Troy Schools District

**BP#3A Smith Middle School – Foundations and Steel -
Addendum #3
February 12th, 2024**

Addendum #3 Bidder Clarifications

S1.2A

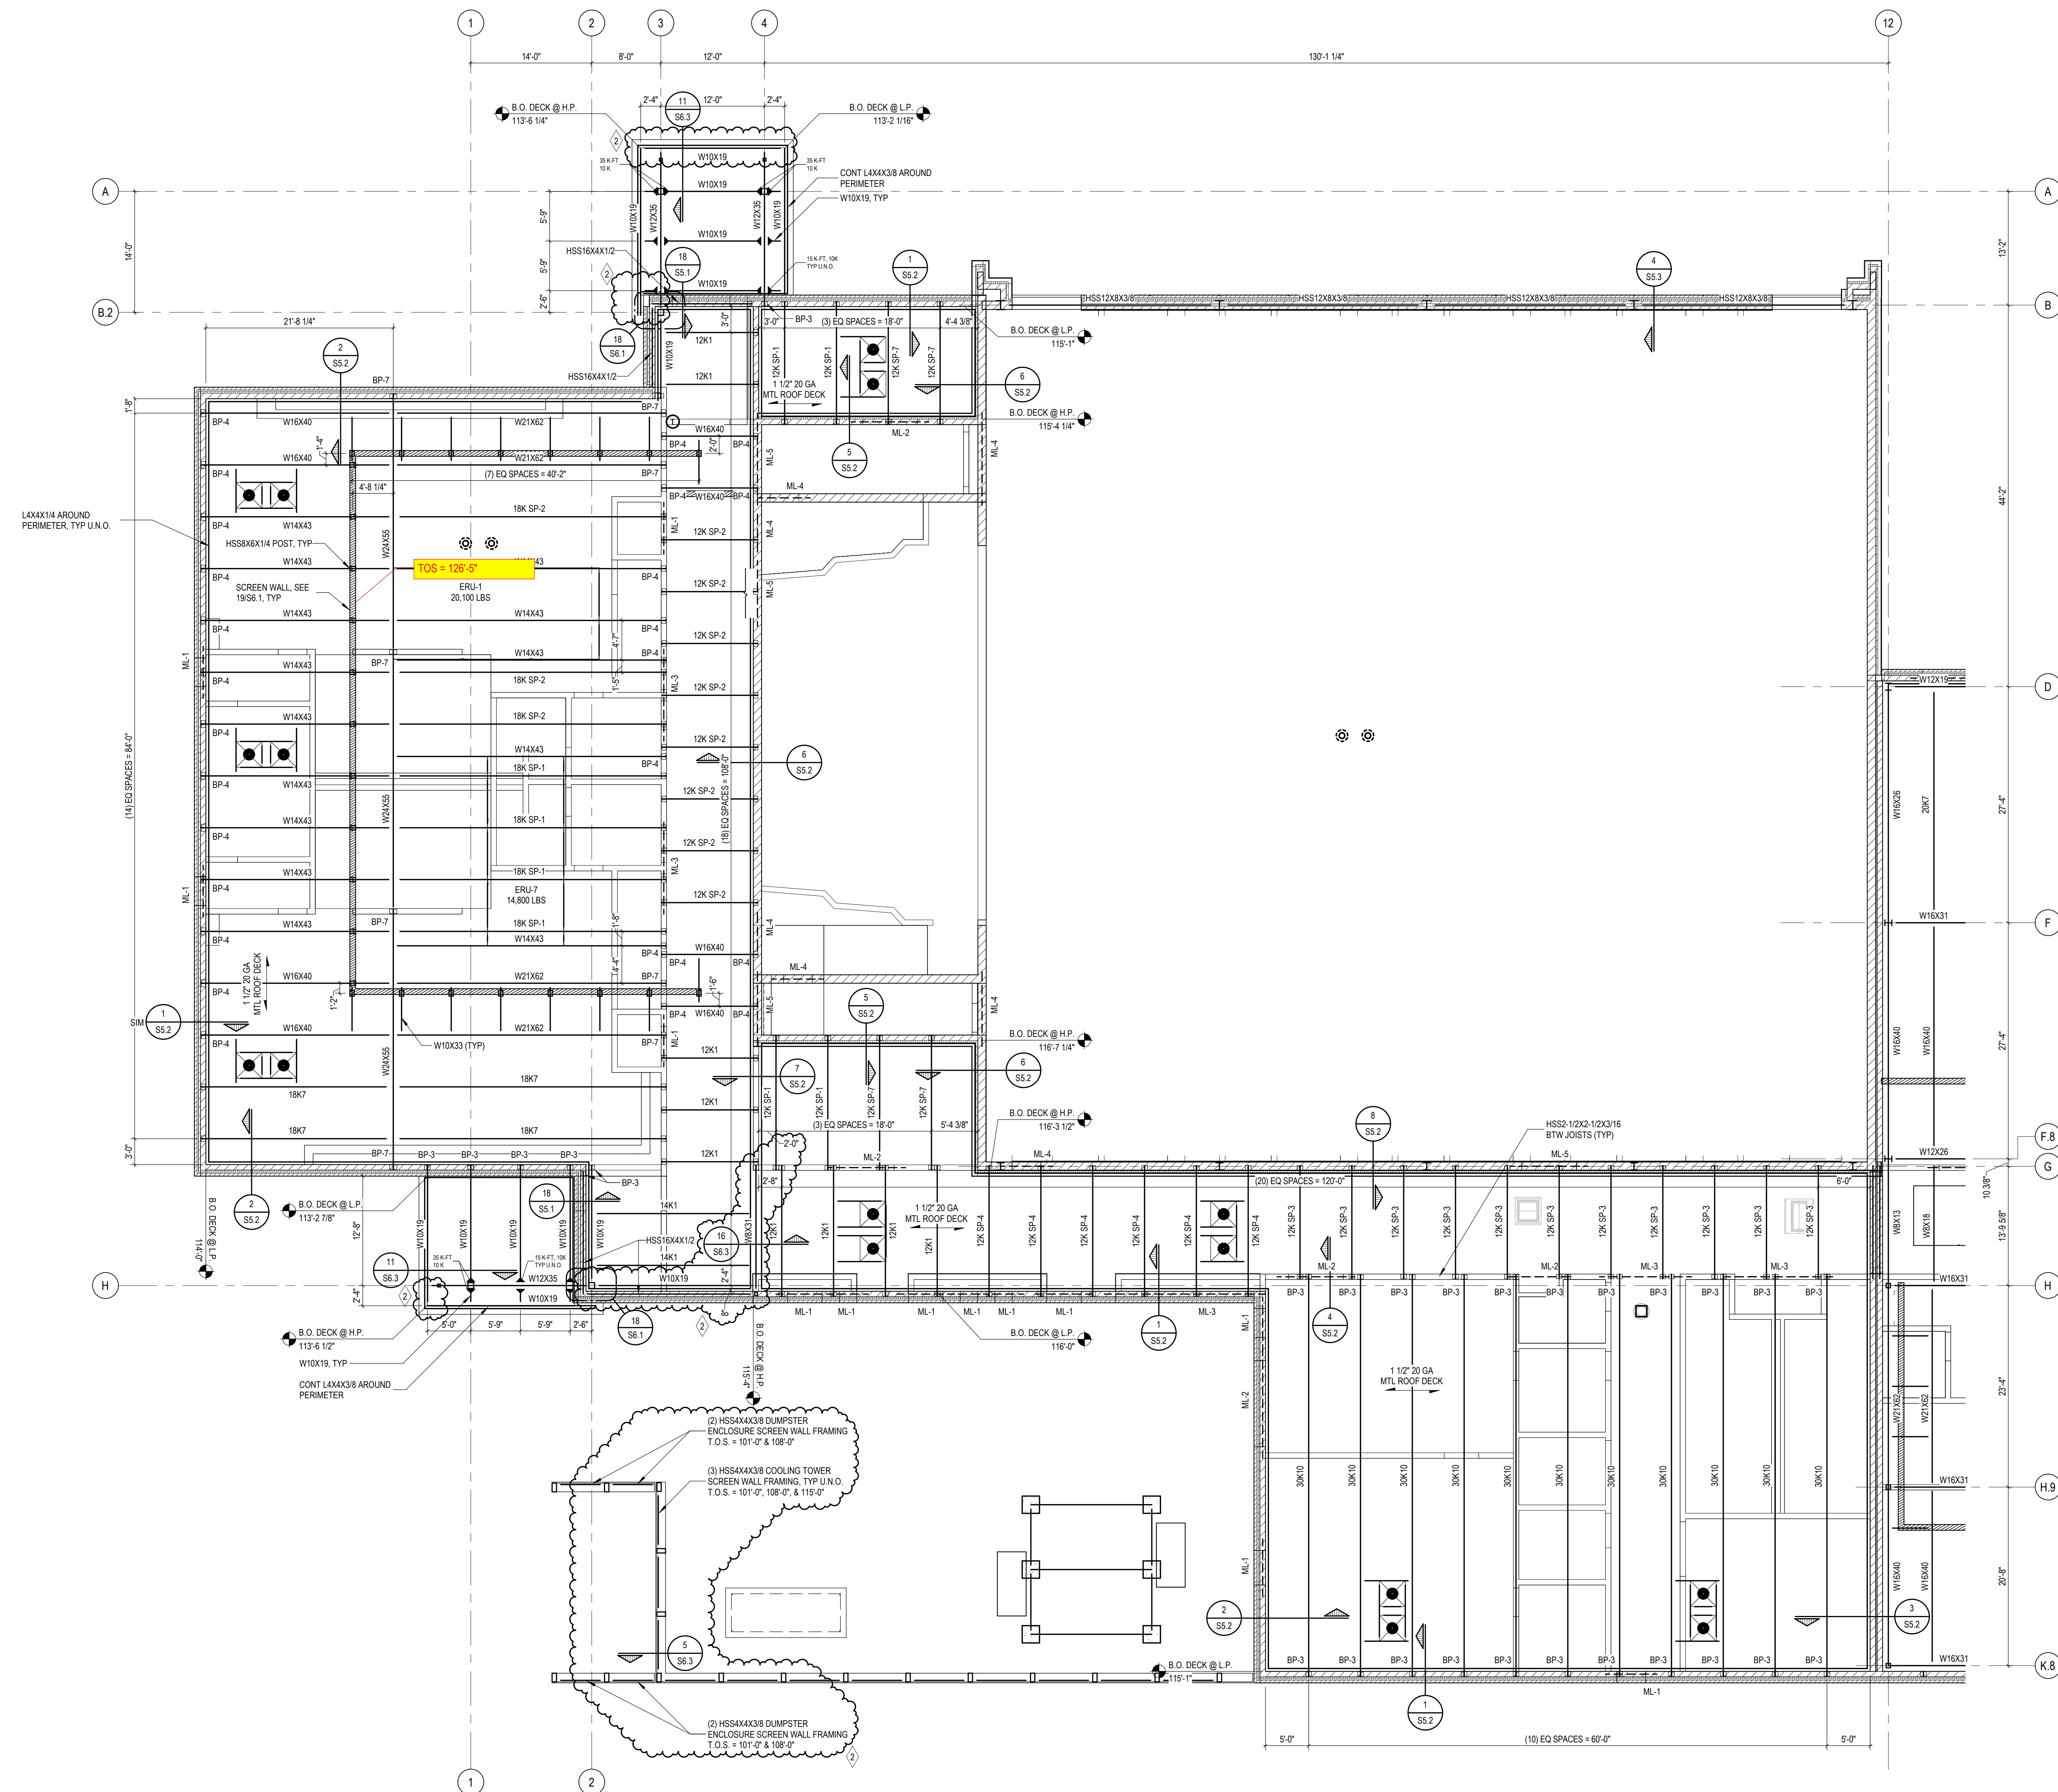
Q: do the HHS 2-1/2x2-1/2x3/16 between joist (ref. S1.2A) apply to all Zones?

A: HSS between joist applies at all interior load bearing CMU walls with joists bearing on top of wall, typical all zones. Locations with HSS between joists at steel beams are noted on the plans/details, but are not applicable if not noted.

S1.2B

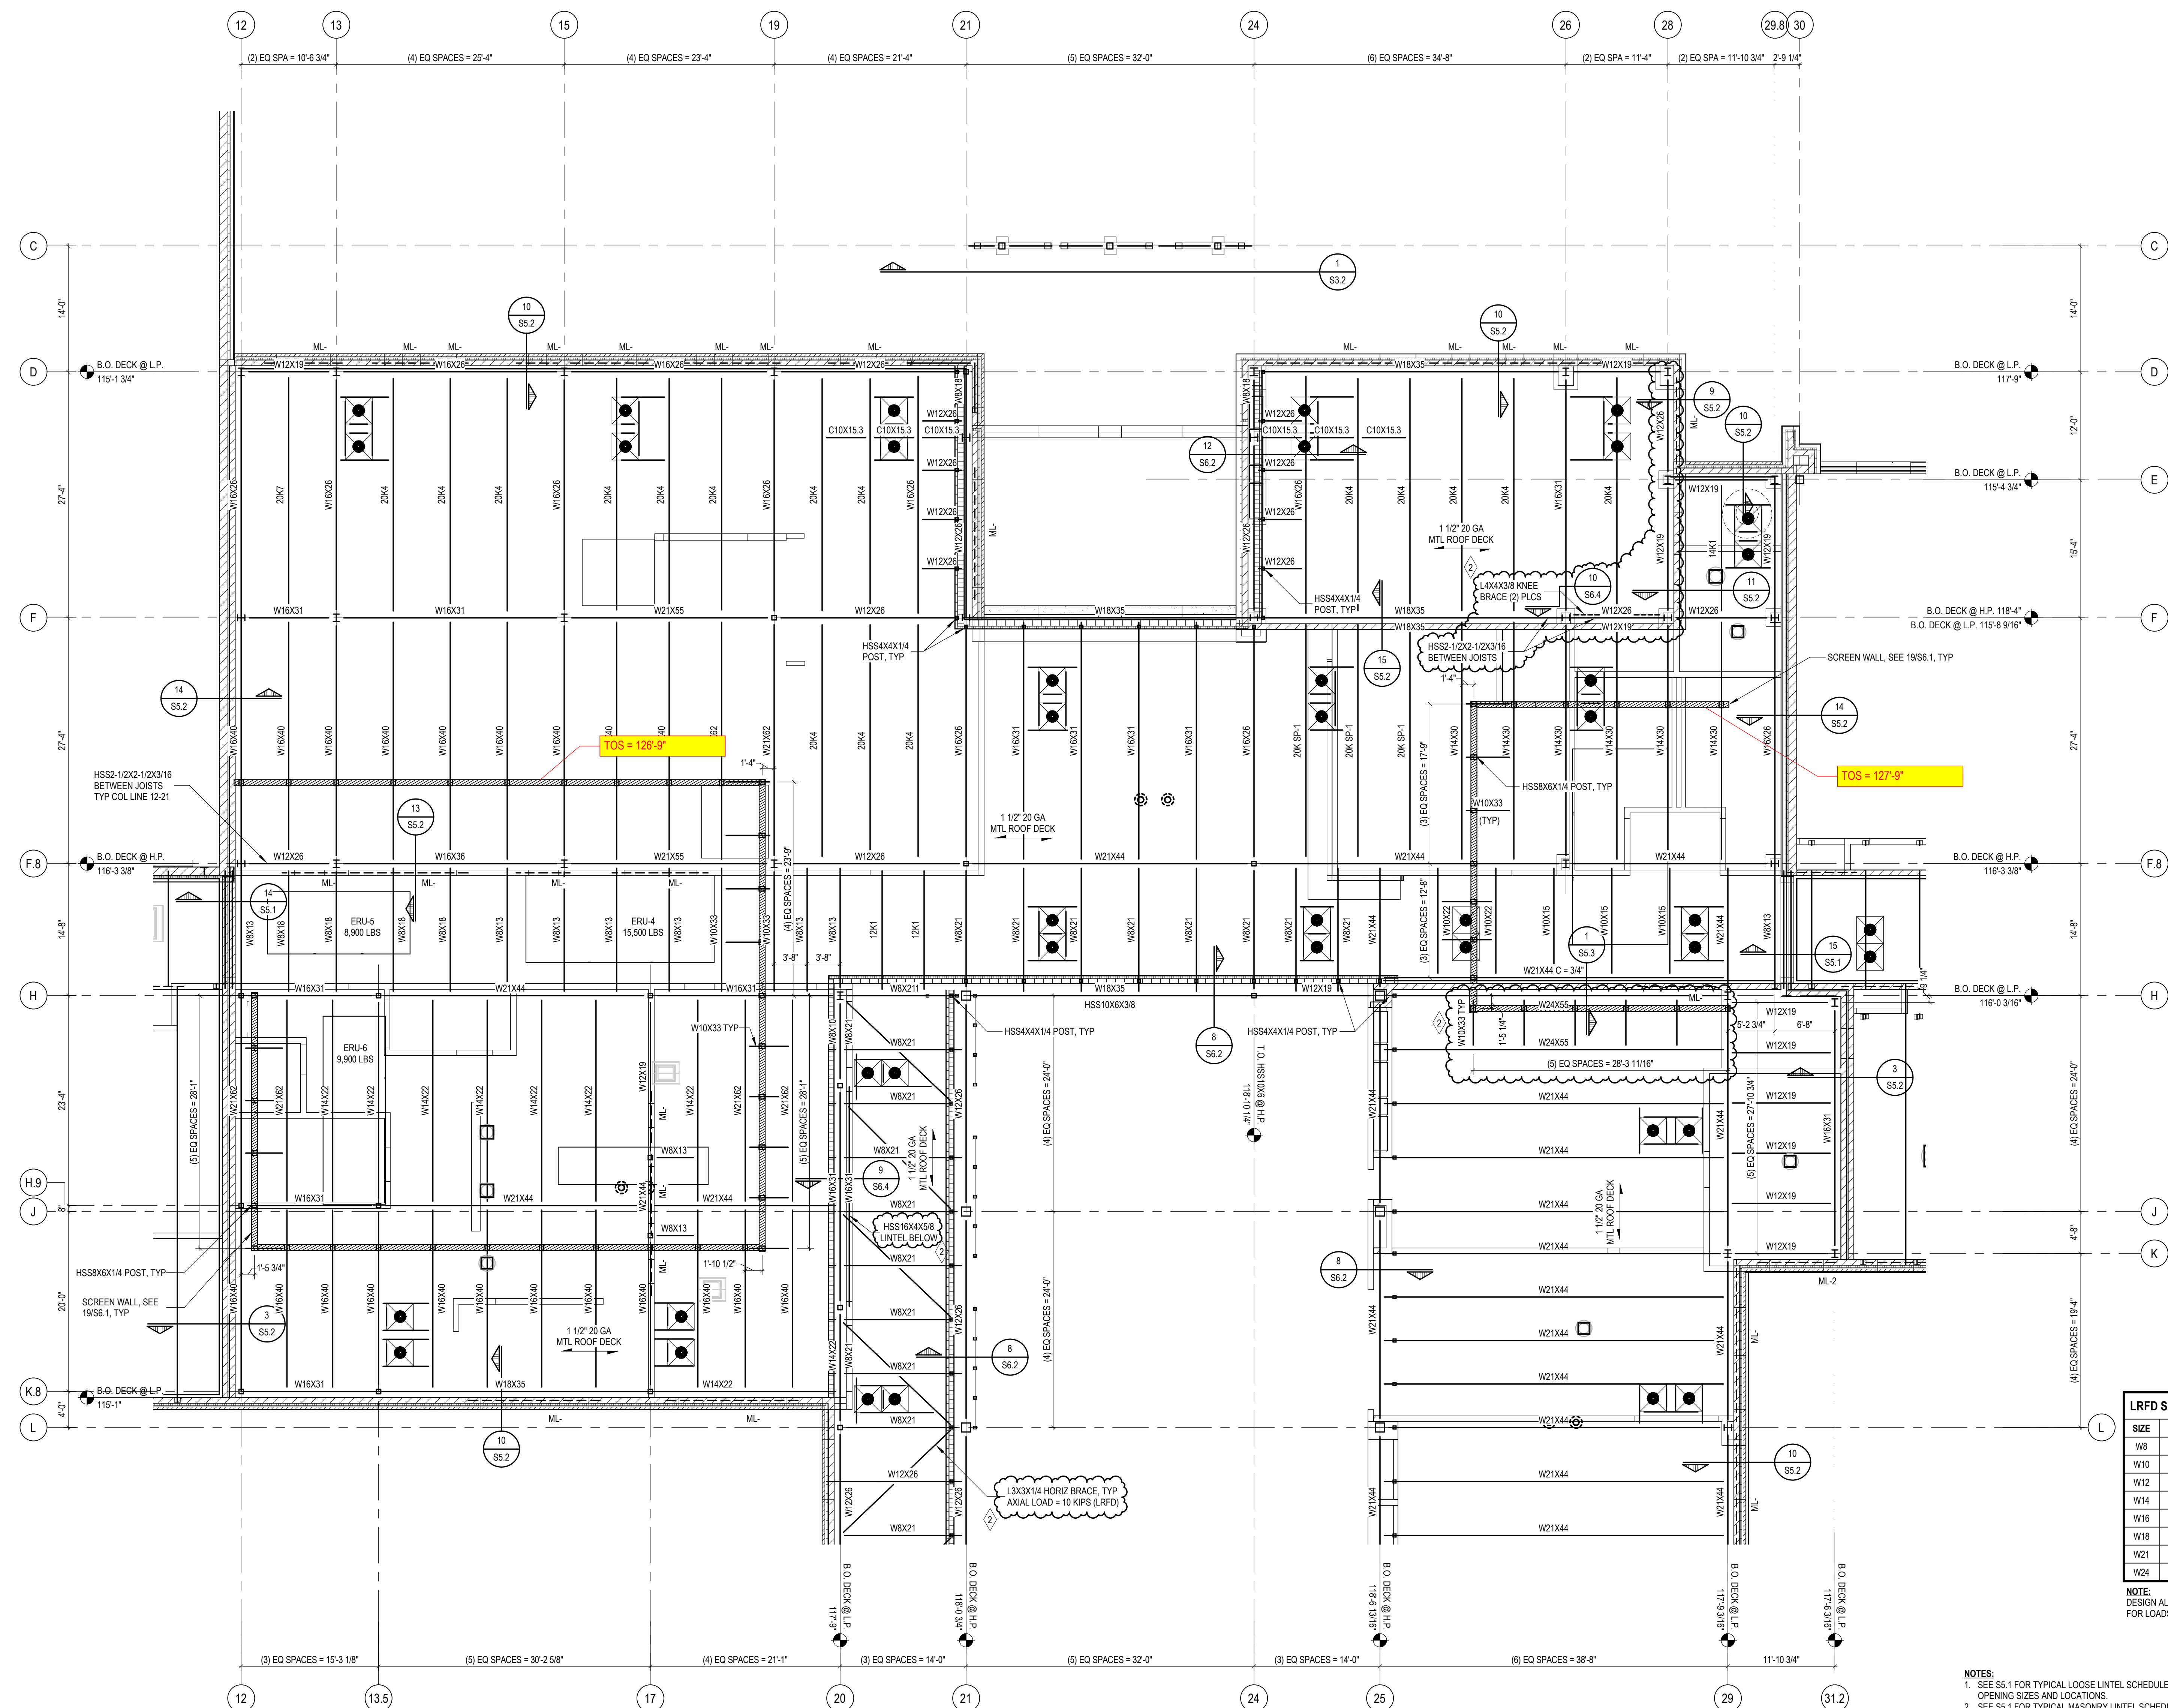
Q: Sheet S1.2B H-line between 20 and 21 line shows W8x211. Please confirm this is meant to be a W8x21.

A: Correct. Beam size should be W8x21.

S1.2F

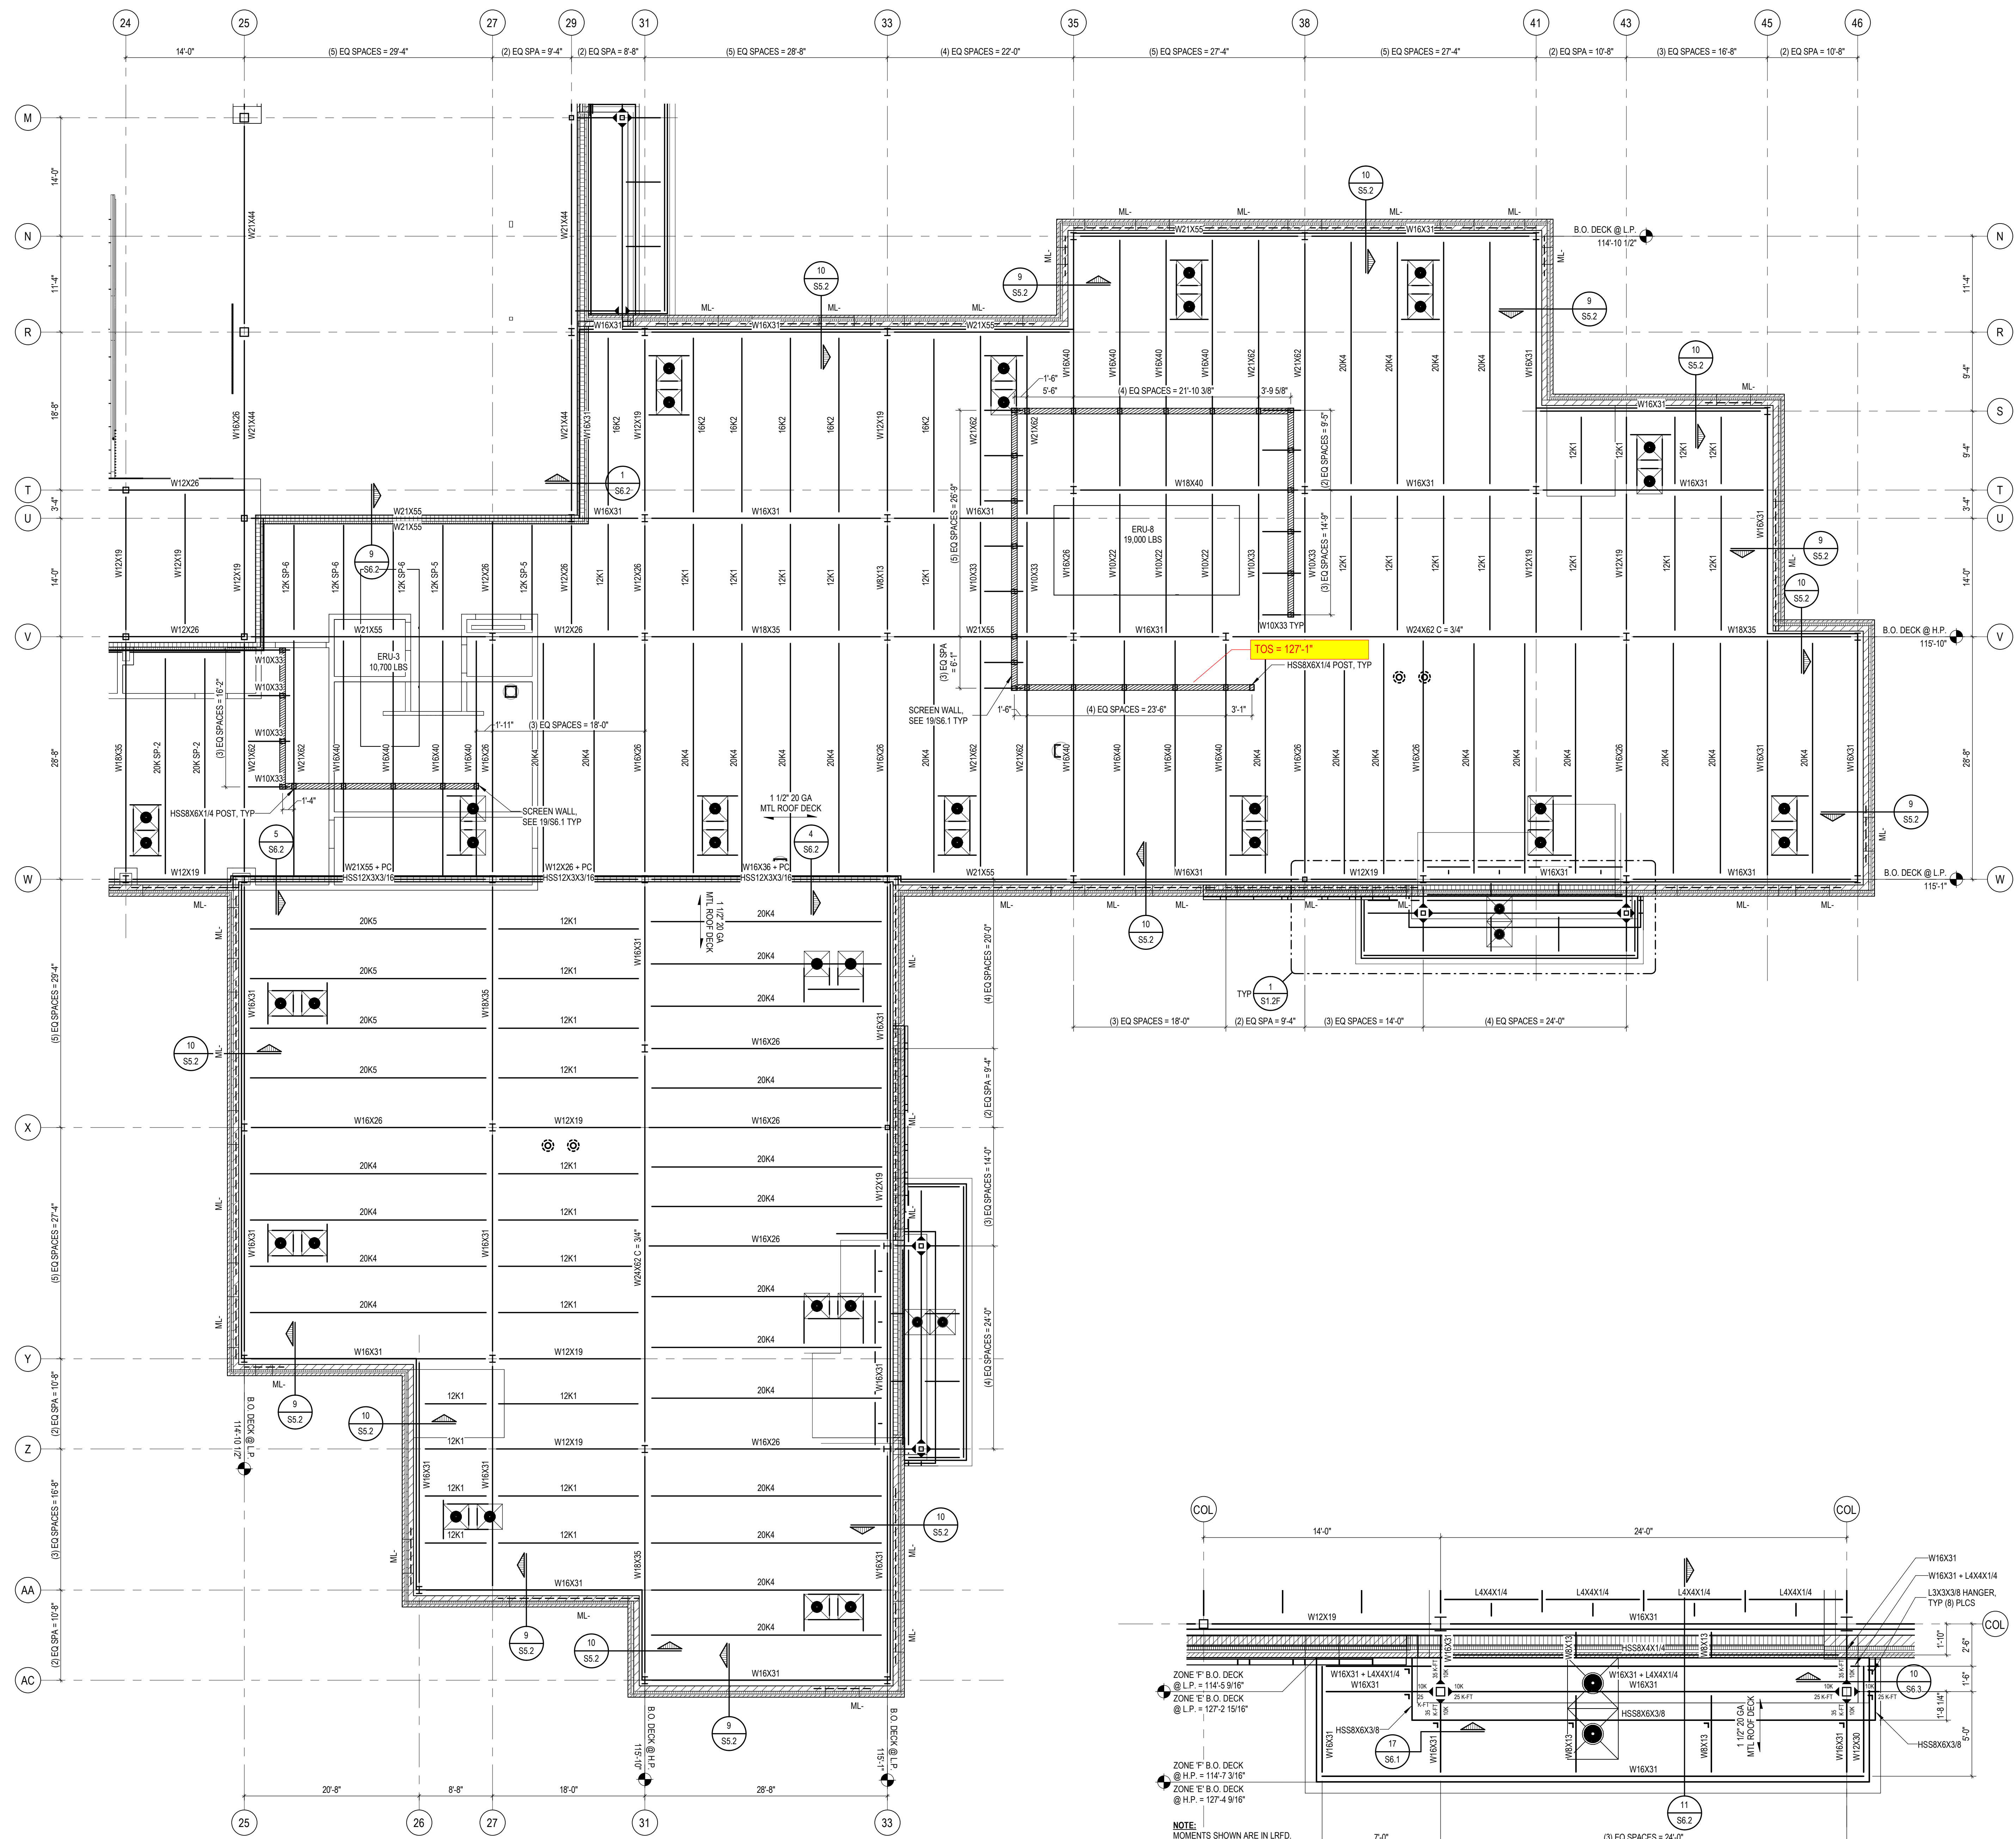
Q: Please verify roof screen wall height relative to top of deck/top of screen wall (ref. section 19/S6.1). Need to know how long the screen wall post will be +/- roof slope.

A: See attached PDF with the screen wall T.O.S. Friday. Screenwall post length will verify depending on location and roof steel slope, top of screenwall elevation is constant and as noted on the markup.
